SEQUOYAH NUCLEAR PLANT

NRC QUESTIONS AND TVA RESPONSES

UNIT 2 CYCLE 11 STEAM GENERATOR INSPECTIONS

EOC-11 Voltage Distribution, SG 1, Revised

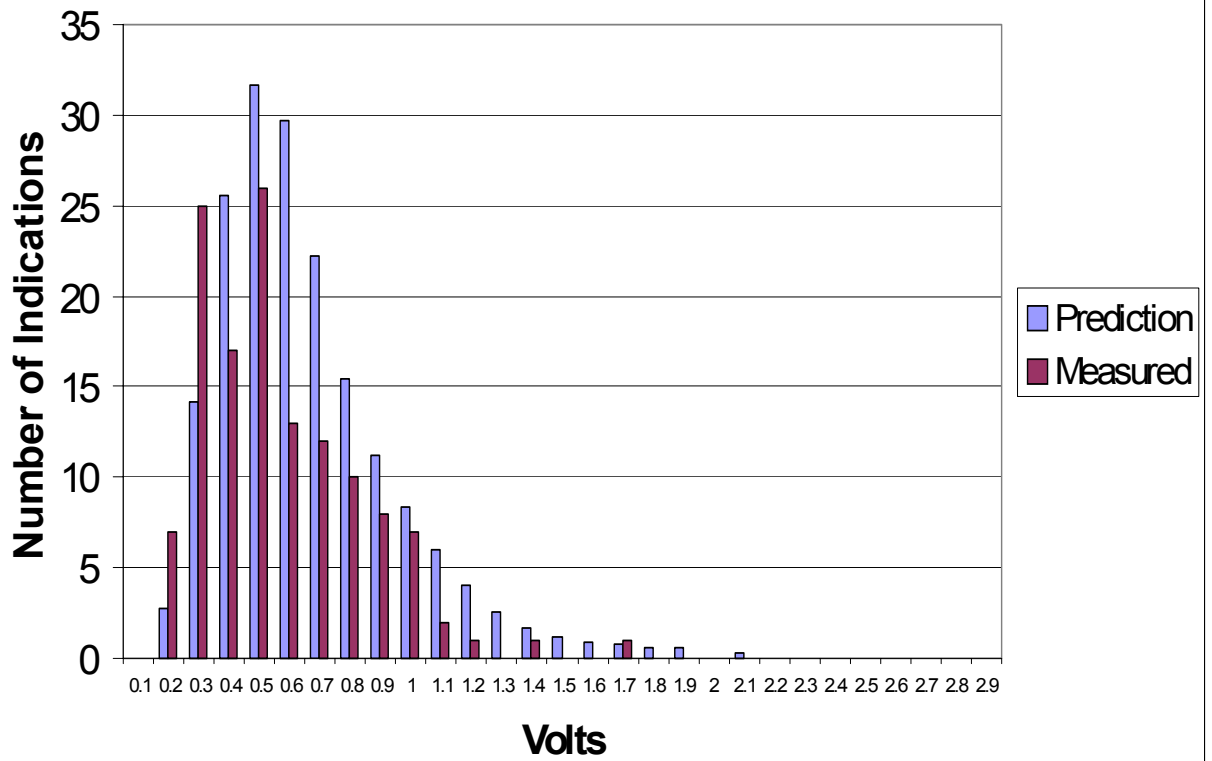
The EOC-11 voltage distribution predictions identified in Figures 4.1 - 4.4 of the July 29, 2002 report appear to be different than the EOC-11 voltage distribution predictions identified in Figures 7.1 - 7.4 of the January 30, 2001 report submitted to the NRC. Explain this apparent discrepancy. If errors are present in one or both sets of figures, clarify if correction of the errors changes any of the details (e.g., results or comparisons) in either of the two reports.

A clerical error was made by the author in the preparation of the final figures of the 2002 report. All comparisons were made with the correct data. This error resulted from a final "clean-up" of the figures. We regret the error and have corrected the figures via TVA's Corrective Action Program (Reference SQN PER 04-770190). The following corrected figures are provided.
